**STATE OF DELAWARE
EXECUTIVE DEPARTMENT
OFFICE OF STATE PLANNING COORDINATION**

May 19, 2010

RE: PLUS review – 2010-04-05; Montchanin Commercial Project

Figure 1: NRCS soil survey update in the immediate vicinity of the proposed project

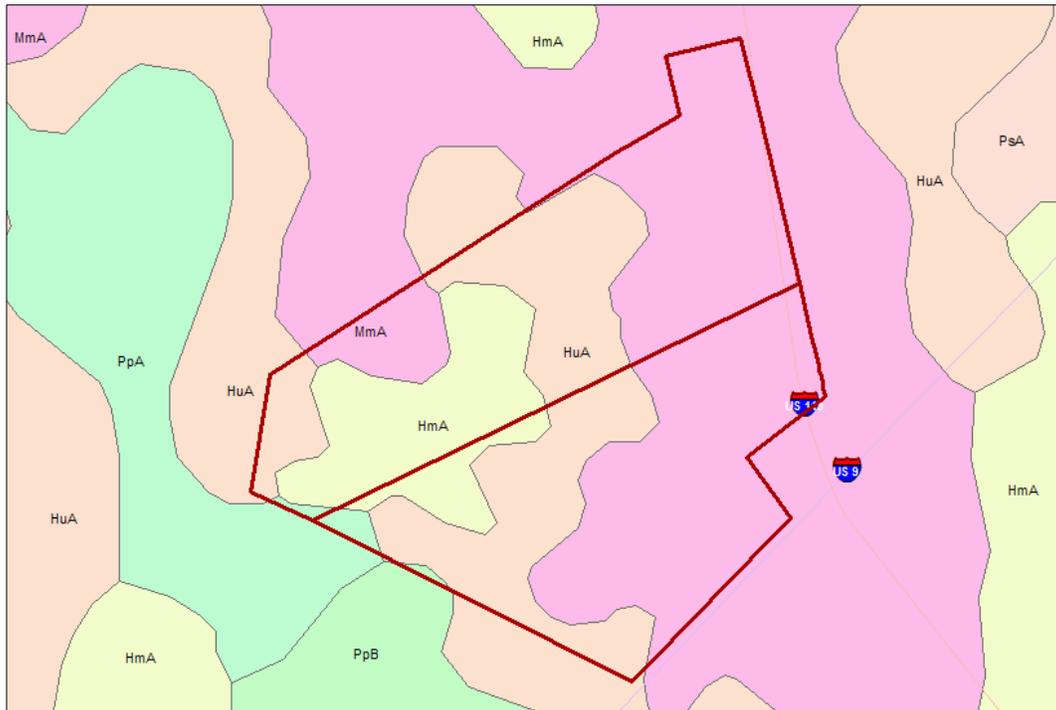
- DNREC strongly recommends that the applicant avoid soils mapped as Hurlock (HuA) and Mullica (MmA). These soils are poorly drained and indicative of wetland conditions (hydric). Building in such soils is likely to leave prospective residents of this and adjoining properties susceptible to future flooding problems from groundwater-driven surface water ponding, especially during extended periods of high-intensity rainfall events such as tropical storms/hurricanes or “nor’easters.” This is in addition to the increased probability of flooding due to or increased surface water runoff emanating from future created or constructed forms of structural imperviousness (e.g., rooftops, roads, parking areas, sidewalks, and stormwater management structures). Approximately 60-70% of the proposed project area contains Hurlock and Mullica soils (See figure 1).
